Access Compliance Report

Public Rights-of-Way

(Curb Ramps)

Intersection ID: 6143	Main Street: COREOPSIS_RD	Cross Street: YARROW_RD	Location: SW
ADA ID: 676A297AFD58	Ramp Type: Perp	Initial Pass/Fail: Fail	Overall Compliance: No
Codes/Mitigation Info/Possible Solution		Field Measurements/Component Compliance	
Severity Score: 13.75

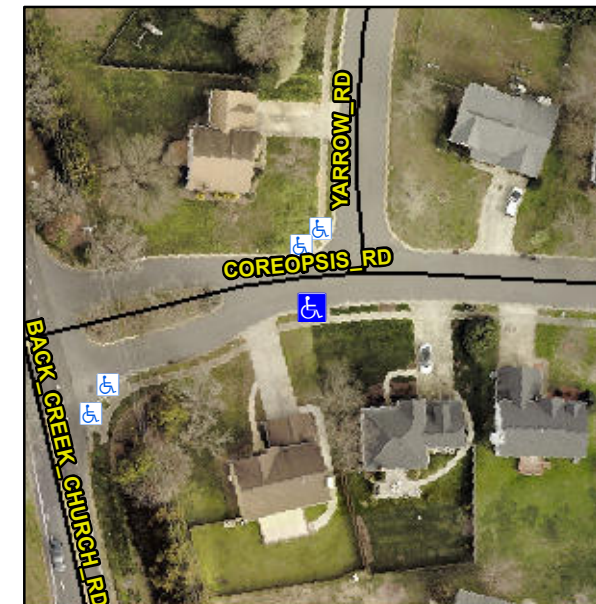
Not Found, R304.2.2

Compliance	Description	Data	Compliance	Description	Data
N/A	Ramp Length (in)	47.0	No	Ramp Slope (%)	11.1
Yes	Ramp Width (in)	66.0	Yes	Ramp XSlope (%)	3.5
N/A	Flare Type LT	N/A	N/A	Flare Type RT	N/A
N/A	Flare Slope LT (%)	N/A	N/A	Flare Slope RT (%)	N/A
N/A	Flare Traversable LT?	N/A	N/A	Flare Traversable RT?	N/A
N/A	Landing Length (in)	N/A	N/A	DWS Provided?	N/A
N/A	Landing Width (in)	N/A	N/A	DWS Contrast?	N/A
N/A	Landing Slope (%)	N/A	N/A	DWS Length (in)	N/A
N/A	Landing X Slope (%)	N/A	N/A	DWS Full Width?	N/A
N/A	Landing Curb? (Y/N)	N/A	N/A	DWS Offset (in)	N/A
N/A	Shared Landing?	N/A			
N/A	Gutter Ponding?	N/A	N/A	Gutter Slope (%)	N/A
N/A	Gutter Lip Ht (in)	N/A	N/A	Gutter X Slope (%)	N/A
N/A	Painted X Walk1?	No	N/A	Painted X Walk2?	N/A
	X Walk 1 Direction	To N		X Walk 2 Direction	N/A
N/A	X Walk 1 Width (in)	N/A	N/A	X Walk 2 Width (in)	N/A
	X Walk 1 Slope (%)	3.9		X Walk 2 Slope (%)	N/A
	X Walk 1 X Slope (%)	3.6		X Walk 2 X Slope (%)	N/A

Remove & Replace Entire Ramp.
